Panel Report

Casey Planning Scheme Amendment C221

McPherson Precinct Structure Plan

4 December 2017

Figure 4 - No Regional Park Future Urban Structure Plan

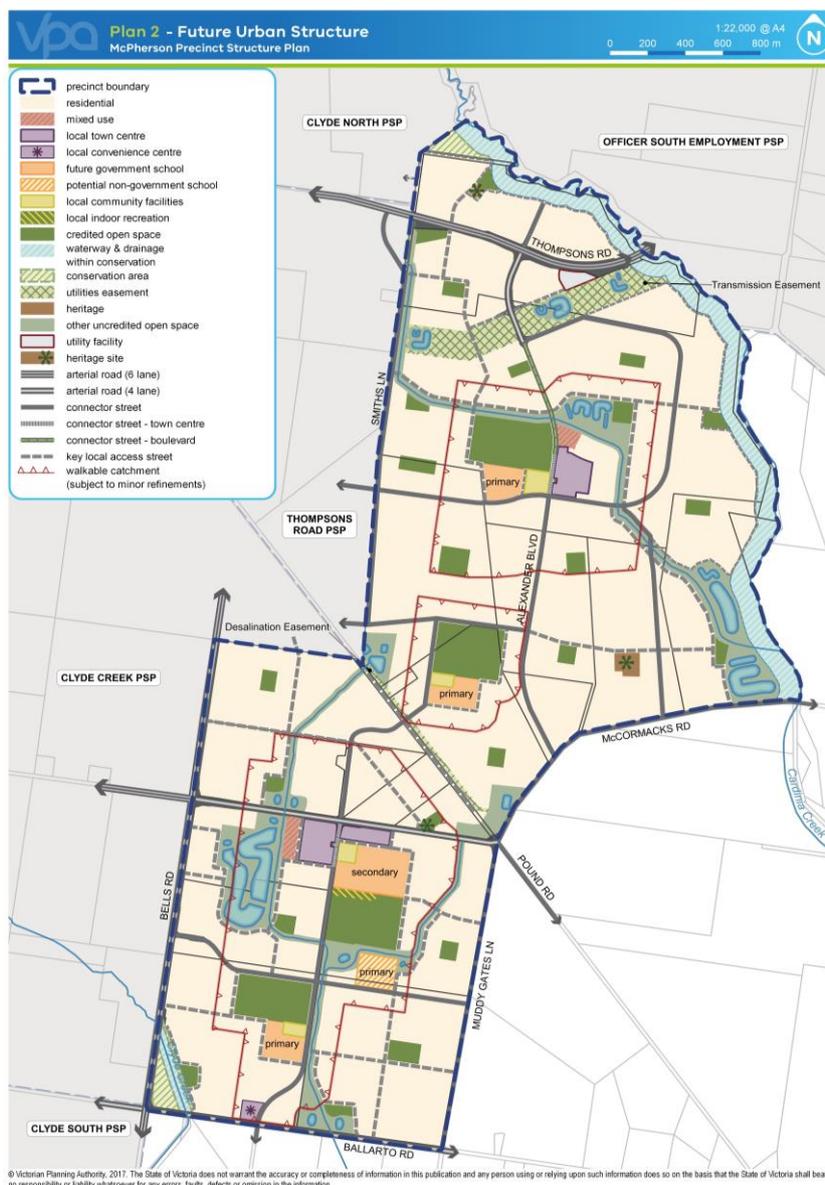
The VPA also advised that a revised FUS had been prepared in response to reconsideration of a proposed regional park in the eastern part of the PSP north of McCormacks Road abutting the Cardinia Creek. DELWP is to decide if the park proceeds but must consult with the relevant commonwealth department which has jurisdiction because the land is included in a Conservation Area pursuant to the Victorian Biodiversity Conservation

The FUS without the regional park replaces it with residential land as it is within the Urban Growth Zone. Otherwise, the FUS remains the same outside of this part of the PSP. The VPA reports the resulting changes lead to:

Figure 6 - Plan 7 - Street Network

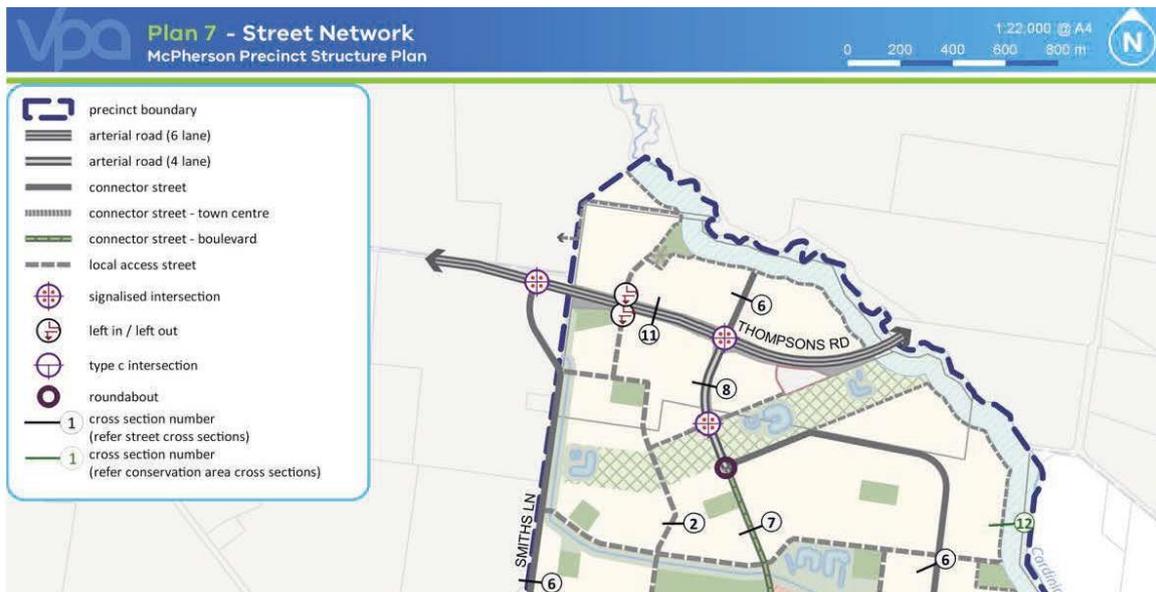
The VPA confirmed the purpose of the PAO3 over part of the submitter's land along the southern boundary of property 2 is to acquire land for an east-west arterial road (see Plan 1: Transport Projects, RD-03). The Panel notes the road project comprises an easterly extension of Thompsons Road from the PSP's western boundary to Alexander Boulevard. The land acquisition creates a 41 metre wide road reserve for an ultimate six-lane east-west arterial road. The Panel accepts the basis for the east-west arterial road along the southern boundary of the submitter's property. Figure 6, extracted from the hearing version of the PSP illustrates the proposed situation.

The Panel considers the VPA response to include the interim designation of a four-way intersection to Thompsons Road/Alexander Boulevard on the PSP is a practical solution to concerns raised by the Submitter.

- 1. Amend relevant maps and words in the Precinct Structure Plan to provide for an interim four-way intersection to Thompsons Road/Alexander Boulevard.**
- 2. Amend the relevant plan in the Precinct Structure Plan (Plan 8) and include words as/where appropriate to maintain location flexibility of the equestrian trail around the perimeter of the Regional Park (With or Without Regional Park versions).**

Figure 7 - Utilities Easement Concept

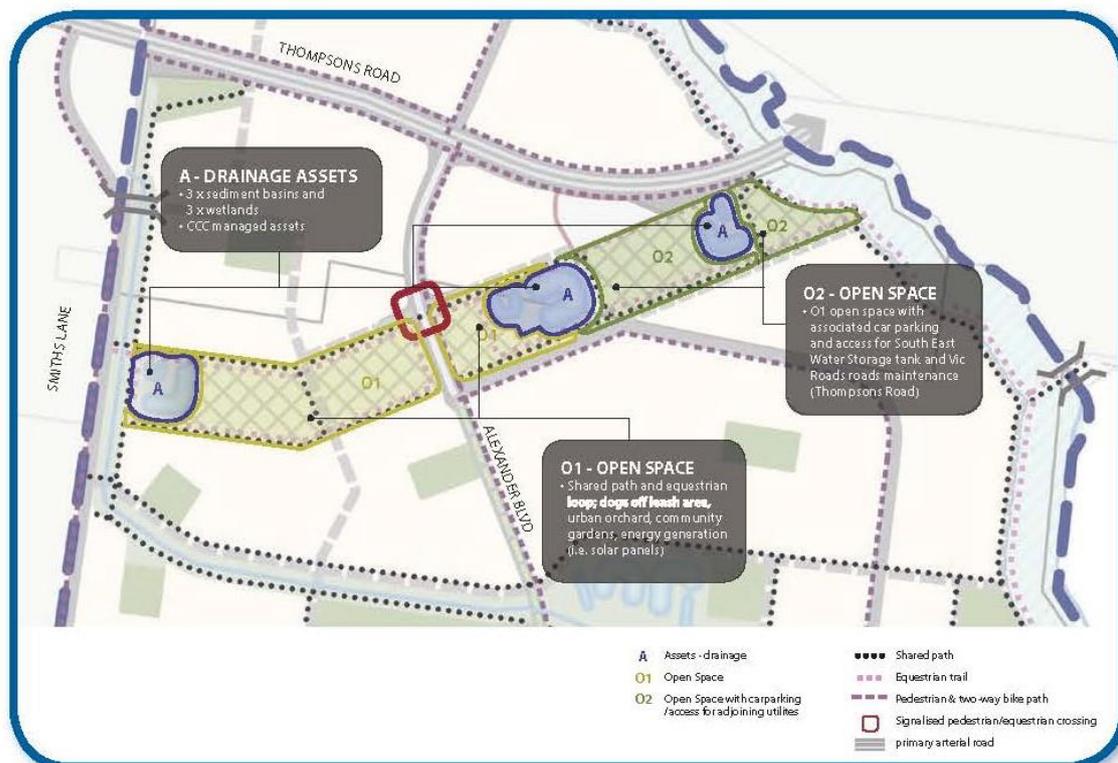
The VPA advised that it had added specific requirements regarding works within the utilities area located diagonally across the submitters' property. On that basis, the VPA advised the

submission was resolved. Figure 7 illustrates the proposed treatment of the land within the utility easement on the submitter's property.

Figure 8 - Conservation Area Interface Plan

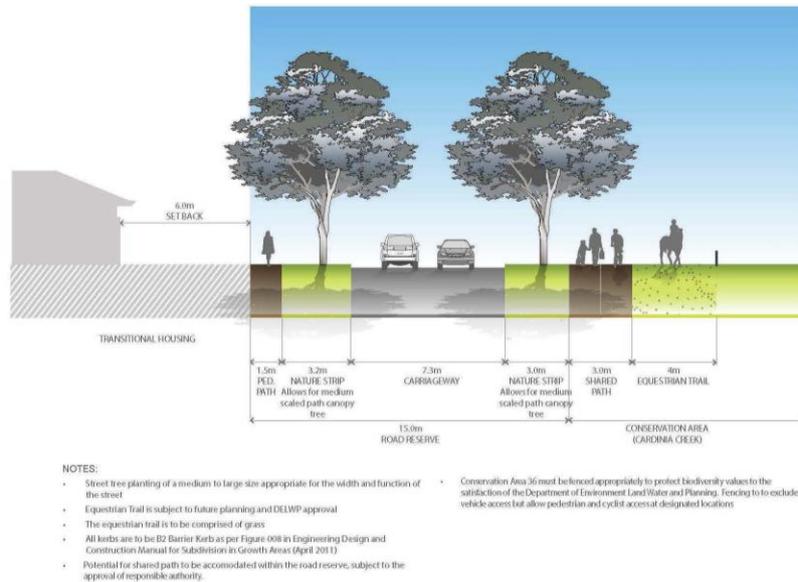
Submitter 16 is generally supportive of the exhibited PSP. However, the submitter considered that further refinement was required to the PSP within the ‘Transitional Housing Area’. The submitter opposes the mandatory minimum lot size of 500sqm, along with a minimum dwelling setback of 6.0 metres to the frontage.

Figure 8 illustrates the treatment of the interface area as proposed in the hearing version of the PSP.

The Panel considers a mandatory minimum lot size in this area of the PSP is not necessary or appropriate, particularly as the agreed wider road reservation provides additional opportunity for landscaping within the public realm. The Panel also considers a mandatory minimum lot size may unnecessarily restrict affordable housing opportunities that will present in the future for this area of the PSP. The Panel considers that the minimum 500 square metre lot size should be placed over this 'Transitional Housing Area' as a discretionary, rather than mandatory planning control in the PSP. In addition, the Panel supports the use of clause 54.03-1 minimum 4.0 metre front setback provisions for these lots, not the minimum 6.0 metre front setback proposed by the VPA.

- a) **Reduced lots down to 500 square metres and apply the 4.0 metre minimum dwelling setback to frontages as specified under clause 54.03-1 of the Casey Planning Scheme.**
- b) **Lots fronting the Cardinia Creek Conservation Area with no front fence and side fences to be no greater than 1.2 metres within the first 3.0 metres of the lot.**
- c) **The 19.0 metre setback identified as a fuel reduction zone within the conservation area to be managed as 'grassland' as outlined in AS 3959-2009 by the relevant public land manager.**
- d) **Reduce the fuel reduction zone so that it ends at the boundary of the dwelling on the lot.**
- e) **Remove the 6.0 metre front setback requirement and increase both nature strips by 1.0 metre each side to achieve a road reservation width of 17 metres.**

Figure 9 - Plan 4 – Image, Character, Heritage & Housing

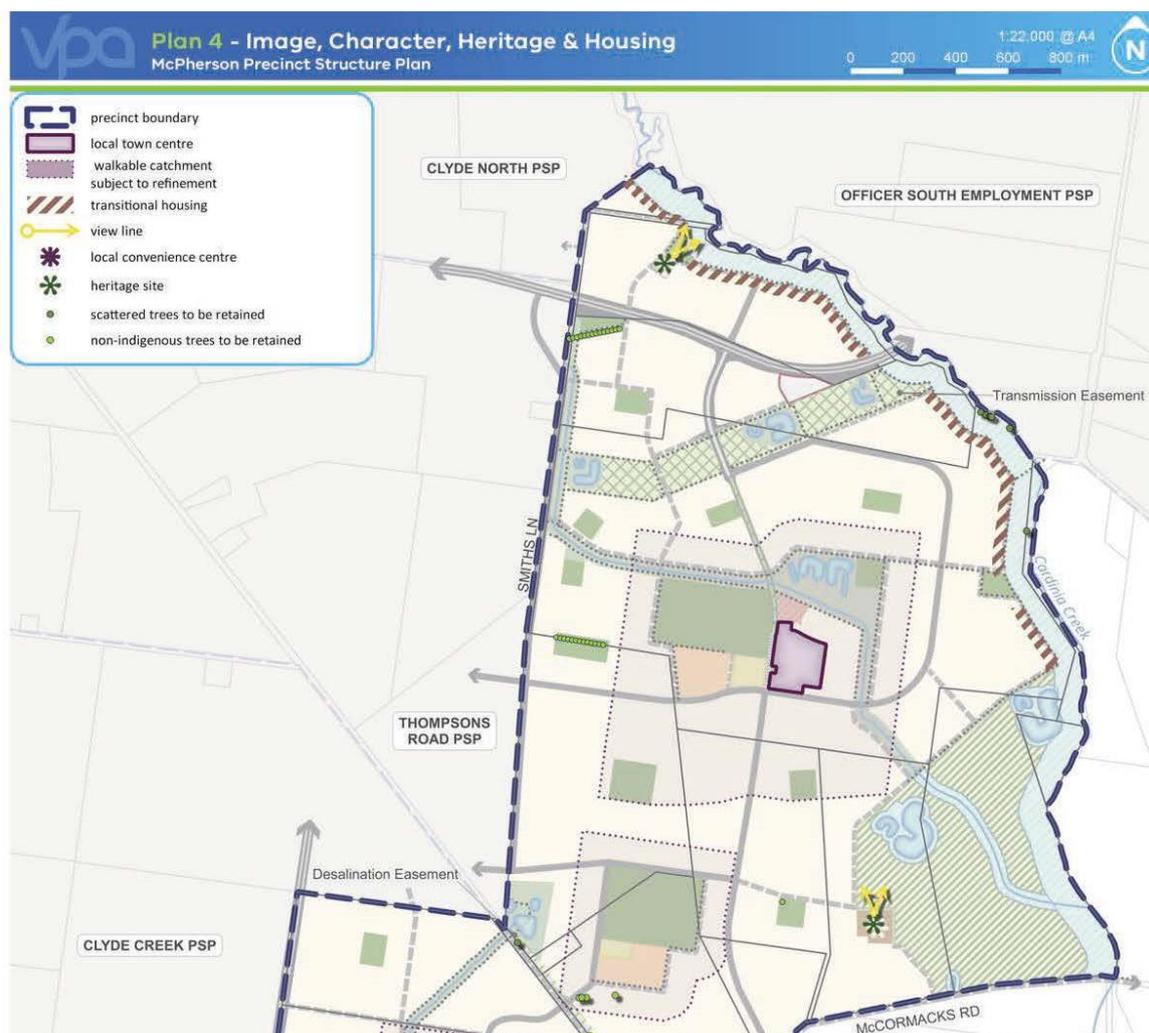
Figure 9, Plan 4 – Image, Character, Heritage & Housing from the hearing version of the PSP identifies the Transitional Housing Area.

- Reduced lots down to 500 square metres but still require a minimum dwelling setback to the frontage of 6.0 metres.
- Lots fronting the Cardinia Creek Conservation Area with no front fence and side fences to be no greater than 1.2 metres within the first 3.0 metres of the lot.
- The 19.0 metres identified as fuel reduction zone within the conservation area is to be managed as 'grassland' as outlined in AS 3959-2009 by the relevant public land manager.
- Reduce the fuel reduction zone so that it ends at the boundary of the dwelling on the lot.
- Remove the 6.0 metre front setback requirement and increase both nature strips by 1.0 metre each side to achieve a road reservation width of 17 metres.

The Panel accepts the recommended post-panel changes proposed by the VPA in respect to the 'Transitional Housing Area' controls designated within the PSP, including appropriate rewording to ensure the minimum lot size this area of the PSP is a discretionary rather than mandatory planning control and the minimum front setback to be applied on these lots is consistent with Clause 54.03-1 of the Casey Planning Scheme.

Figure 10 - Concept Plan – Conservation Area 36 (Cardinia Creek Corridor)

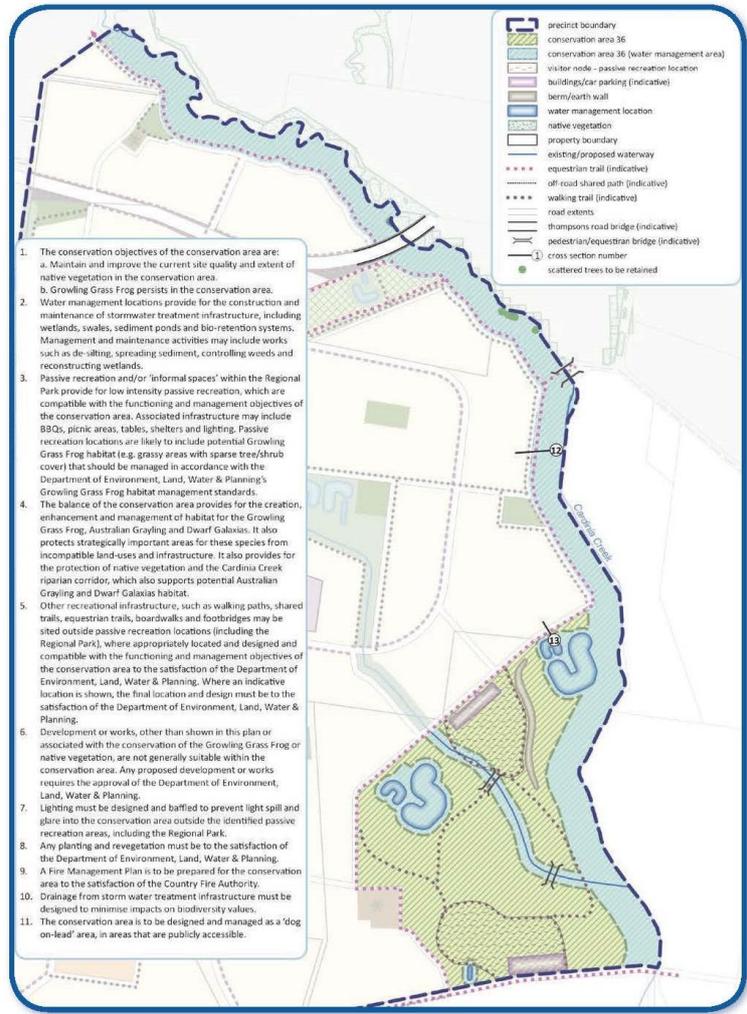
Figure 6 in the PSP titled Concept Plan – Conservation Area 36 (Cardinia Creek Corridor) illustrates the proposed treatment of the submitter's property and Property 10 which the Panel discusses in section 4.2.5. The plan is repeated at figure 10.

3.4 Biodiversity, Threatened Species & Bushfire Management										Exhibited wording	Proposed changes	
Figure 6: Conservation Area Concept Plan - Conservation Area 36 (Cardinia Creek Corridor)										Exhibited figure	Proposed changes	
											Update figure 6 to be consistent with cross sections - conservation cross section	
Plan 8: Public Transport & Path Network										Exhibited plan	Proposed changes	
										8	Plan 8 Between pattersons road and the next connector, show bike path on eastern side to align.	Vpa improvement
										8	Plan 8 updated plan to be consistent with cross sections - i.e. town centre main street cross section.	Vpa correction
Plan 9: Integrated Water Management										Exhibited plan	Proposed changes	
										9	Correct the colour of Cardinia Creek -as Cardinia Creek should not be identified as a constructed waterway.	VPA correction
											Potential to include the word 'indicative' before 'constructed waterway'

Figure 11 - Integrated Water Management Plan

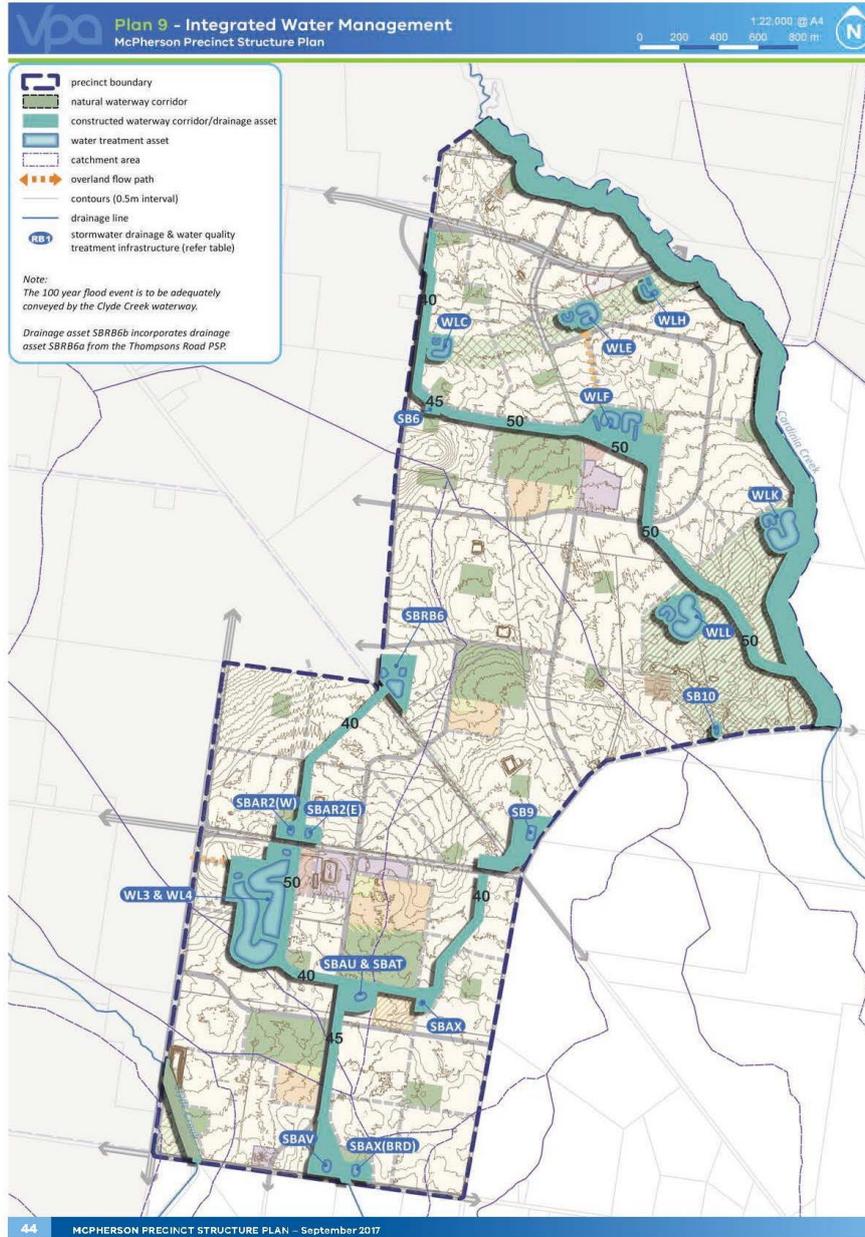
To address the submitter's concerns, post-panel changes were also proposed by the VPA that provided greater flexibility for drainage design in the PSP. The following text *'indicative and may be changed and modified to the satisfaction of Melbourne Water and Responsible*

Authority' is to be added into Plan 9: Integrated Water Management (reproduced at figure 11 in section 4.2.6). The submitter supports these drafting changes but continues to rely on all of its other submissions.

Plan 9, Integrated Water Management, in the hearing version of the PSP was the plan addressed by Mr Beardshaw. It is repeated as figure 11.

- (d) At Plans 2,3,4,5,7,8,9 and 10 delete the waterway running through Properties 15 and 16.

Figure 12 - Street Network plan

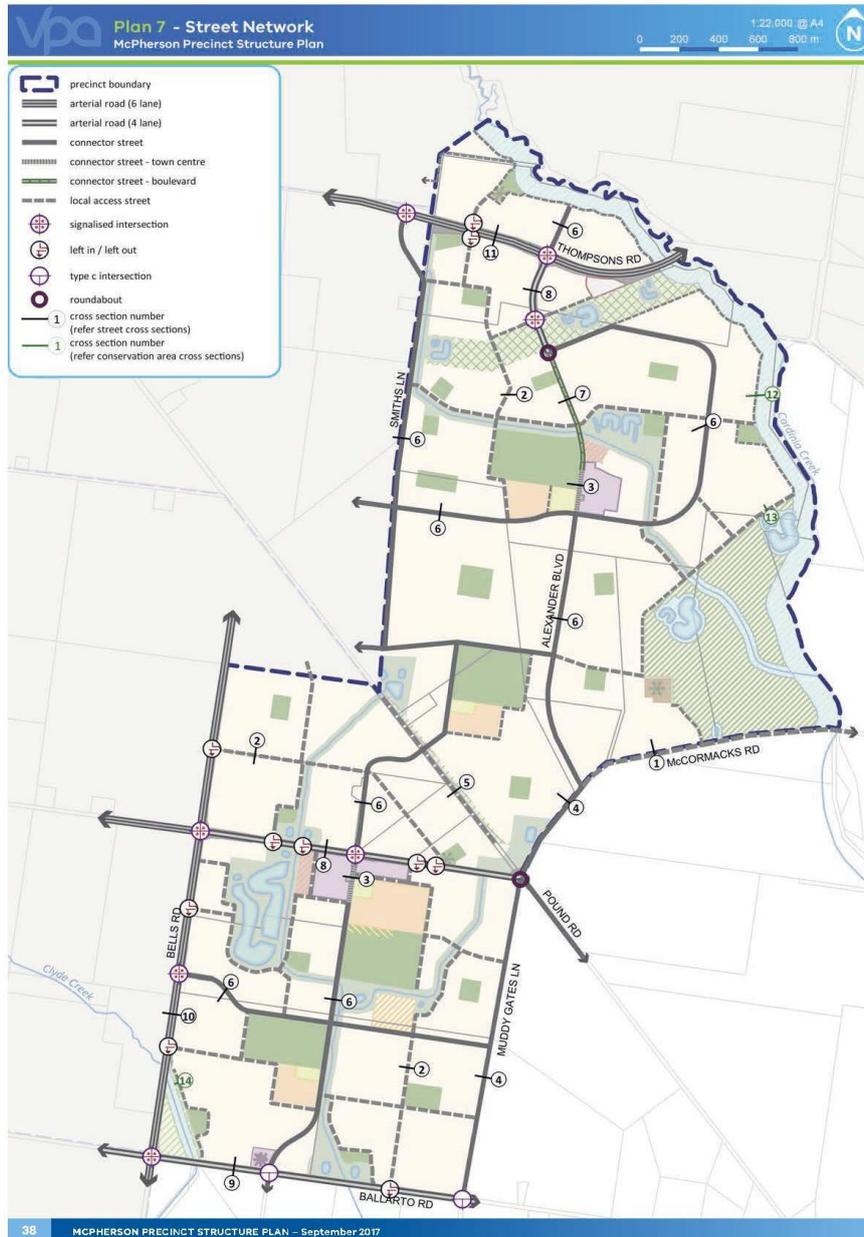
Submitter 14 sought additional information on the need for the *Key Access Street* extending north to connect with the future Thompsons Road extension (shown on figure 12, the Street Network Plan, in section 4.2.6).

Plan 7, Street Network, in the hearing version of the PSP was the plan addressed by Mr Turnbull. It is repeated as figure 12.

- 3. Amend wording in the Precinct Structure Plan documents to ensure an appropriate level of flexibility is provided about the final location and ultimate treatment of key arterial road networks and connections throughout the Precinct Structure Plan.**

Figure 13 - Extract Open Space plan

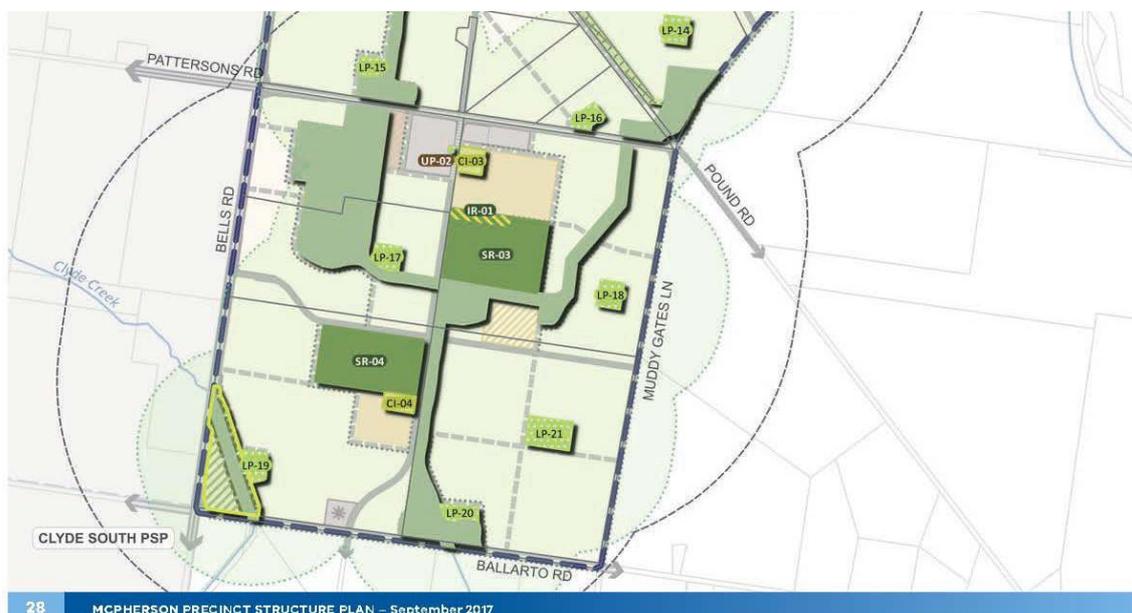
Submission 21 from Peter Tisdale, the owner of property 19, expressed his concern for the amount of land from his property proposed as the site for a utility installation for Melbourne Water, as well as land for a local park identified as LP-16 on plan 5, Open Space and Community Facilities.

The need for the allocated 0.85 hectares of land for a local park on the property will be established at the time of subdivision. If a change to the configuration is required, change away from the layout in the PSP can be achieved under Requirement 38 which states *All parks must be located, sized and designed generally in accordance with the location shown on plan 5 and relevant description in Table 5 unless otherwise approved by the responsible authority.* For LP-16, the City of Casey is the control agency so the decision rests with council.
